CITY OF AUSTIN
Board of Adjustment/Sign Review Board
Decision Sheet

CASE NUMBER: C15-2010-0103

ADDRESS: 2505 LONGVIEW ST

CITY OF AUSTIN – WATERSHED PROTECTION AND DEVELOPMENT REVIEW DEPARTMENT
SITE PLAN APPLICATION – MASTER COMMENT REPORT

SITE PLAN

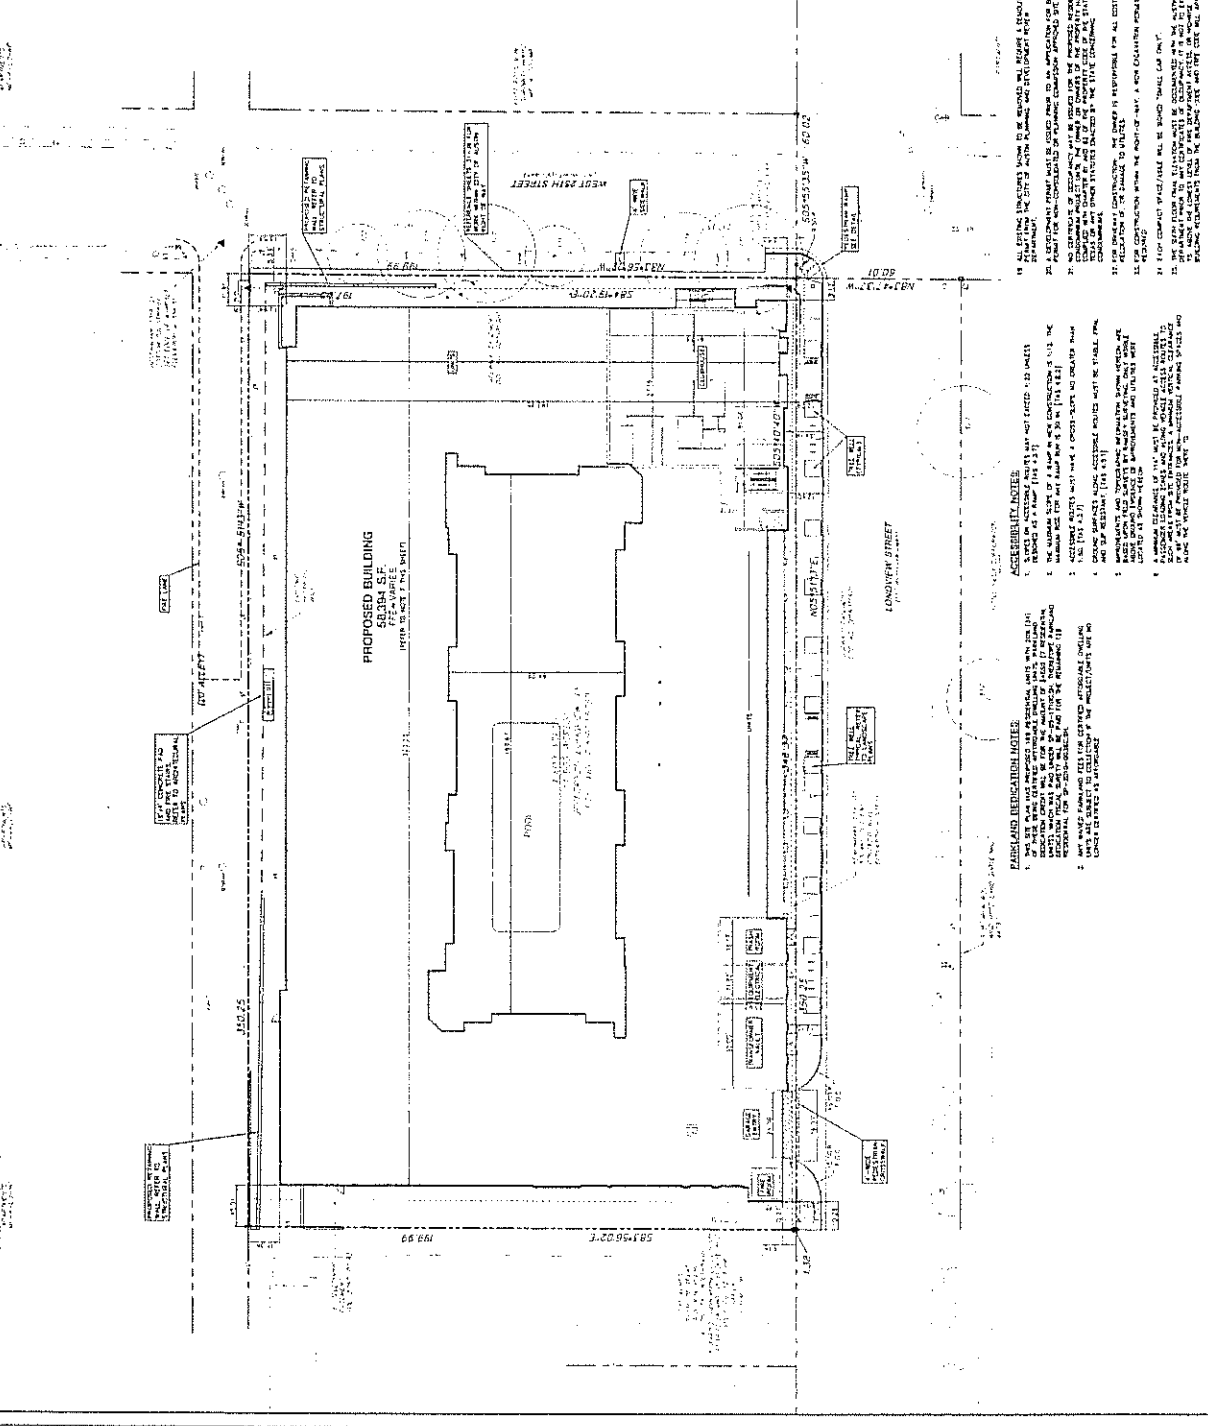
SP 7 According to Section 25-2-761, for sites with frontage on an alley 20 feet or more wide: a transformer room or utility vault must be adjacent to and accessible from the alley; and - a pump room, sprinkler room, or other utility or mechanical room must be adjacent to and accessible from the alley unless the Fire Chief determines that placing the room in another location is required because of a fire safety issue. The site plan shows these utilities located off of Longview St, and not the alleyway – please demonstrate compliance or clarify.

U1. The site plan is not meeting this requirement. Staff understands the applicant has a hardship due to grading issues; however, there is no administrative variance option given for this code requirement. The Fire Chief may determine that placing the pump room,

sprinkler room, or other utility or mechanical room (associated with Fire requirements) may be located elsewhere because of a fire safety issue, but a transformer room or utility vault must still be adjacent to and accessible from the alley. If the applicant cannot meet this requirement through redesign, staff recommends the applicant visit the Board of Adjustment for a variance request. Please contact Susan Walker, Planner at 974-2202, or Diana Ramirez, Administrative Specialist, Board Secretary at 974-2241 to begin this process.

The location you have for the transformer vault will work for Austin Energy's Network Department.

If the grade is worse on the back alley, we would not want the vault in that location.

Longview Architectural		Longview Street Partners, LLC	
2505 Longview, Austin, Texas		2505 Longview, Austin, Texas	
DESIGNED BY: JAV		DESIGNED BY: JAV	
CHECKED BY: LMB		CHECKED BY: LMB	
PROJECT NO: 2103-01		PROJECT NO: 2103-01	
SHEET 25		SHEET 25	
OF 40		OF 40

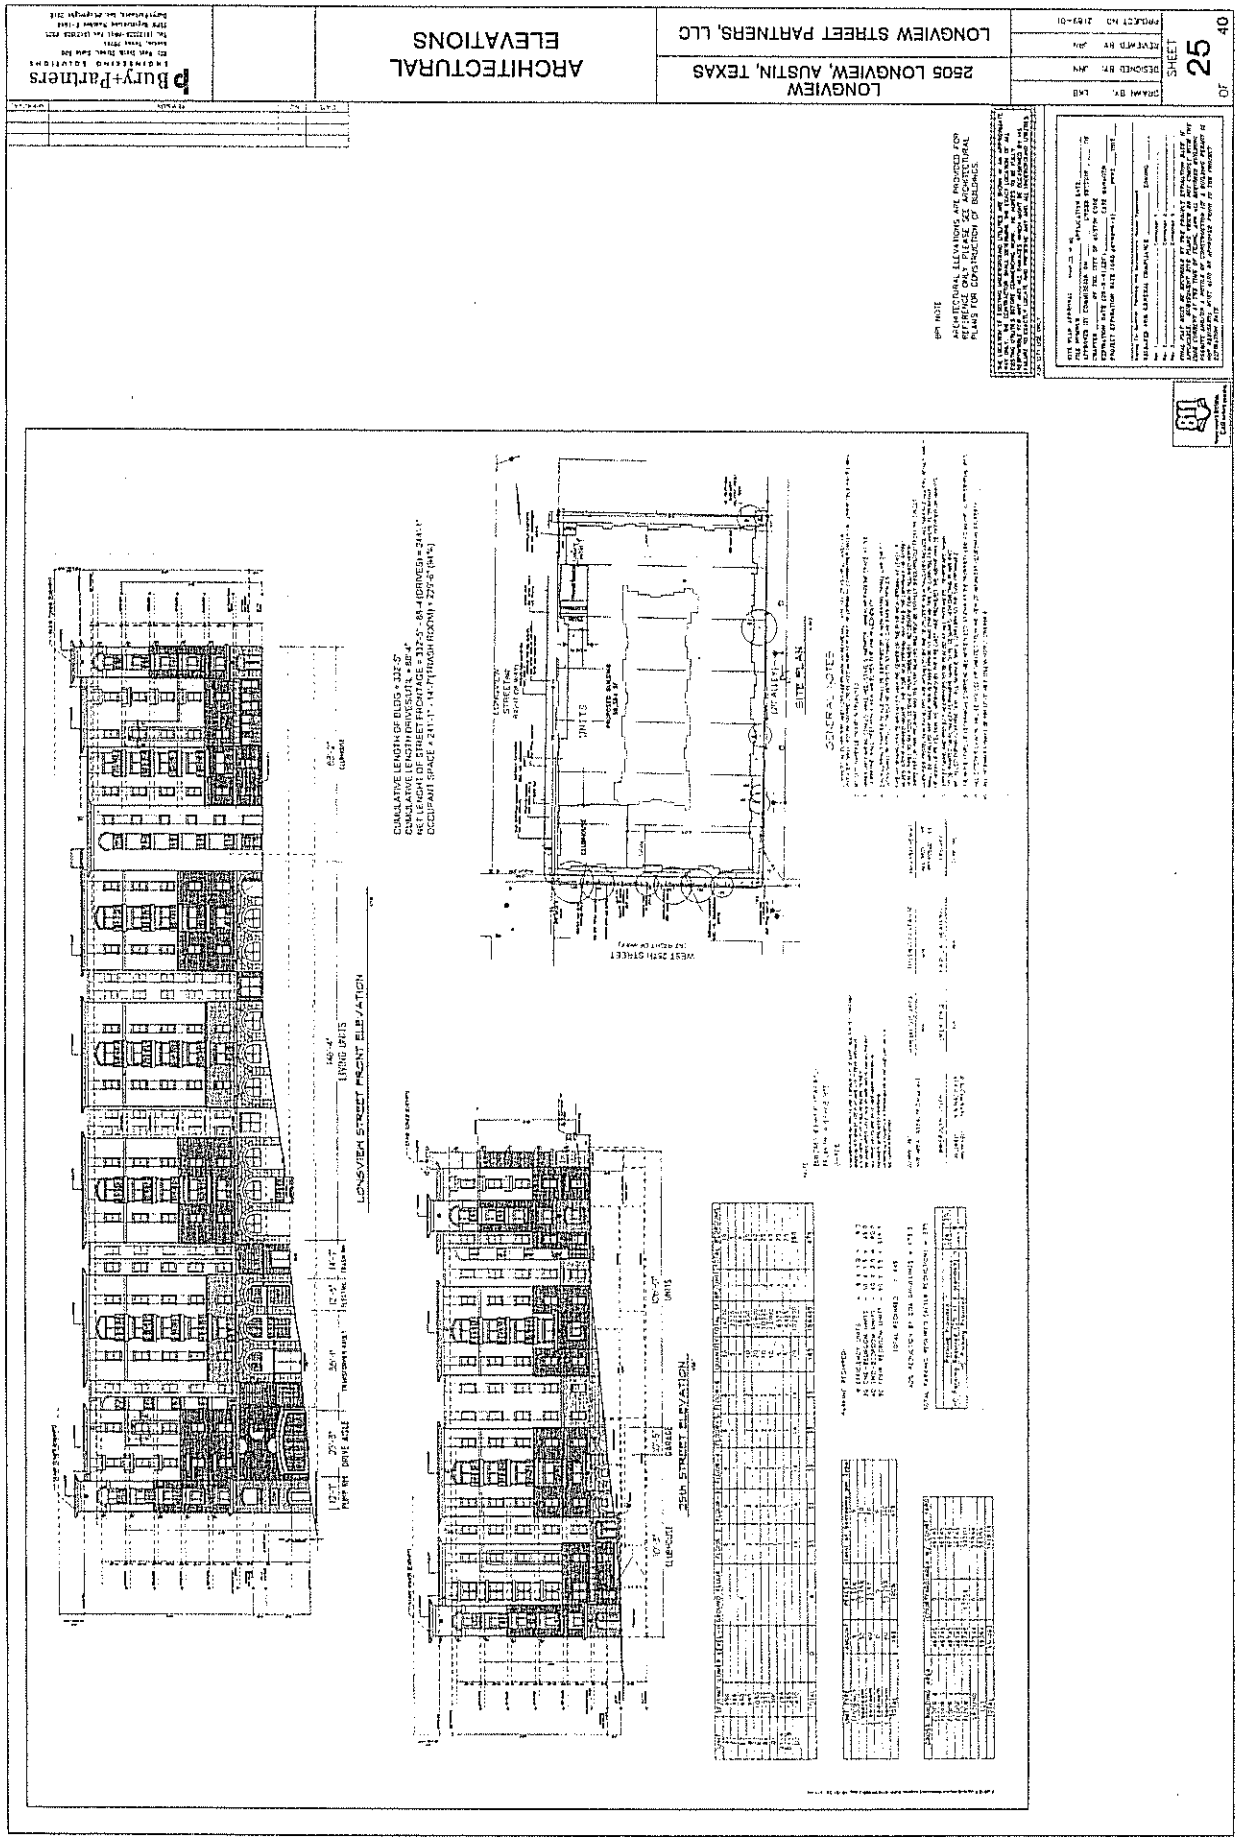
SP 2 Please demonstrate compliance with Section 25-2-758 - the exterior wall facing W. 25th Street must be setback from the lower portion of the wall by a distance of at least 12 feet for the portion that is over 60 ft. Show this on sheet 25 – Architectural Elevations.

U1. Reviewer found no changes on sheet 25 – please demonstrate compliance.

ENTRY GRADING DETAIL
SCALE 1"=10'

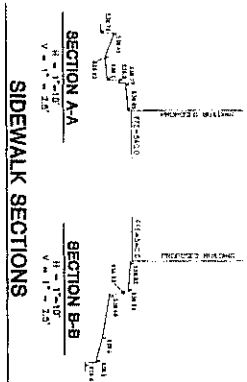
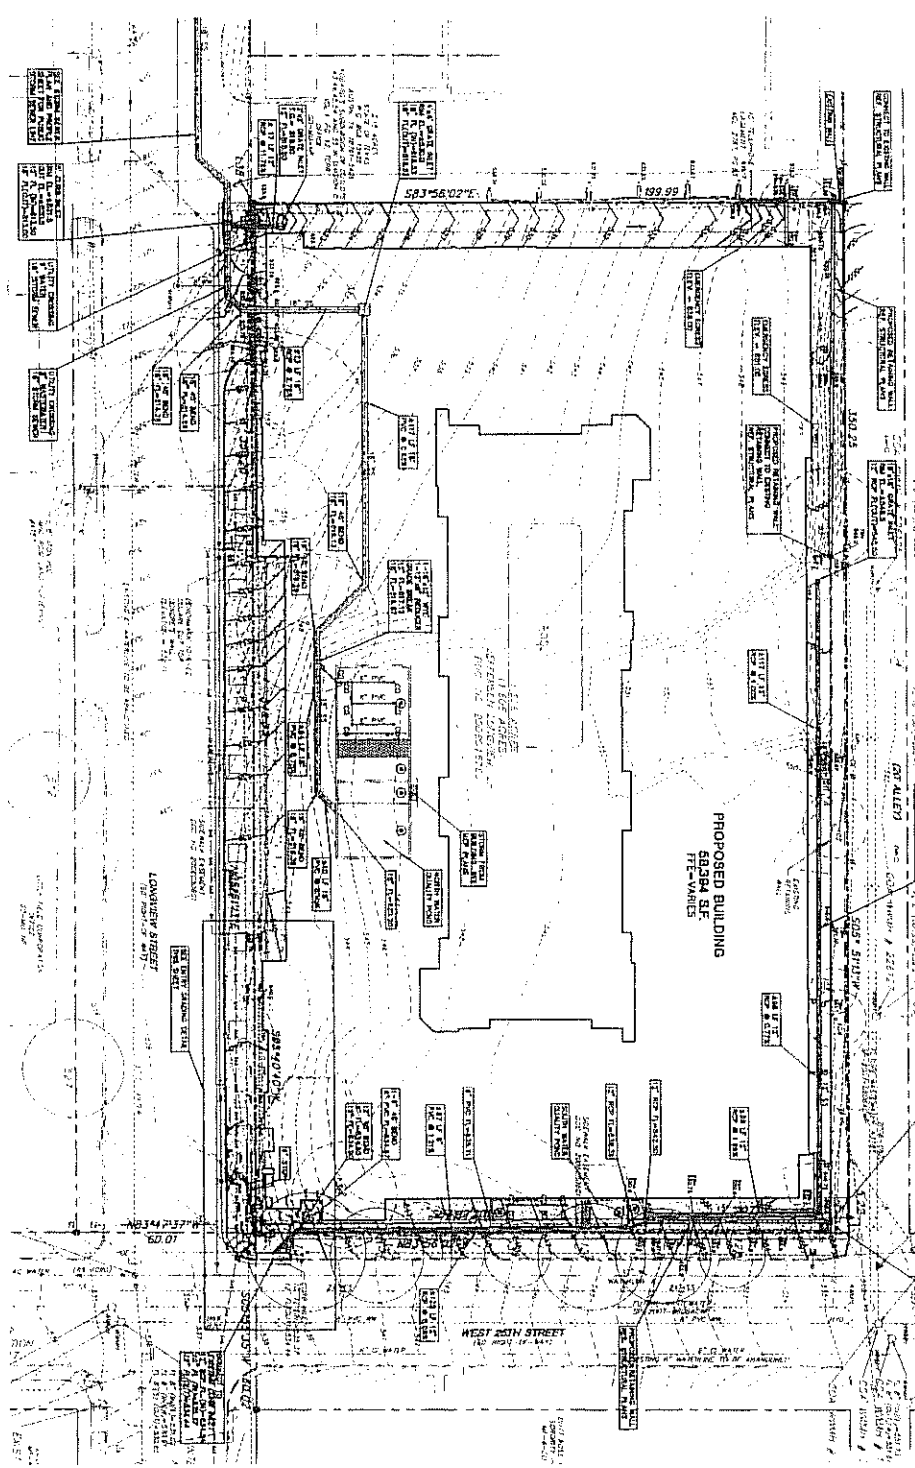
U1. The site plan is not meeting this requirement. Staff understands the applicant has a hardship due to grading issues; however, there is no administrative variance option given for this code requirement. Staff recommends the applicant visit the Board of Adjustment for a variance request. Please contact Susan Walker, Planner 974-2202 or Diana Ramirez, Administrative Specialist, Board Secretary at 974-2241 to begin this process.

Due to the existing topography along Longview Street and West 25th Street, it is not possible to meet Land Development Code section 25-2-754(H)(3) which requires that the ground floor of a building must not be more than five feet higher or lower than an adjacent public street sidewalk. There is an elevation change from 521 msl to 540 msl along Longview Street which is a difference of 19.5 feet over a 346 foot run. There is also an elevation change from 540 msl to 556 msl along West 25th Street which is a difference of 16 feet over a 200 foot run. Due to this significant grade change a ground floor elevation of 540 was selected and is located at the corner of the Longview Street and West 25th Street intersection. Regrading of the site and adjacent roadways is not possible as it would eliminate the roadway and sidewalk connectivity.
